Product/Process Change Notice (PCN)

PCN #: ConCRD_20140430
Product Affected: 693071010811
Effective Date: 2014-06-01

Product without BoPET (OLD)	Product with BoPET (NEW)

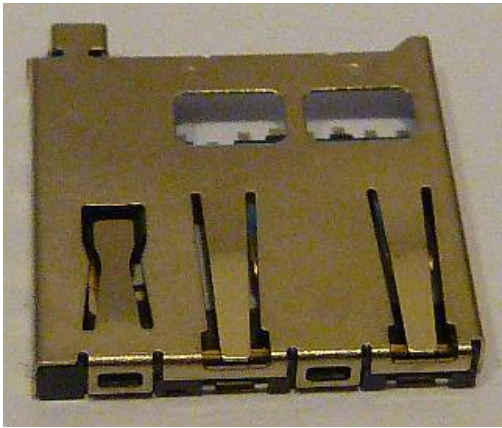
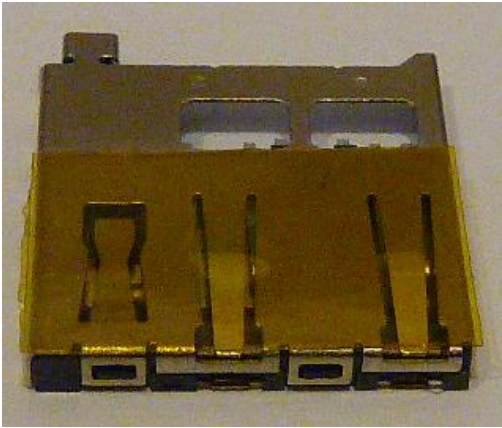
Product change have been done in regard to improve pick & place. The effective date code begins with 2014-06-01.

We added Biaxially-oriented polyethylene terephthalate (BoPET) on the top surface of the connector. Nevertheless, the product design remains the same. No dimension, electrical and mechanical properties are changed. The BoPET film needs to be removed after placement.
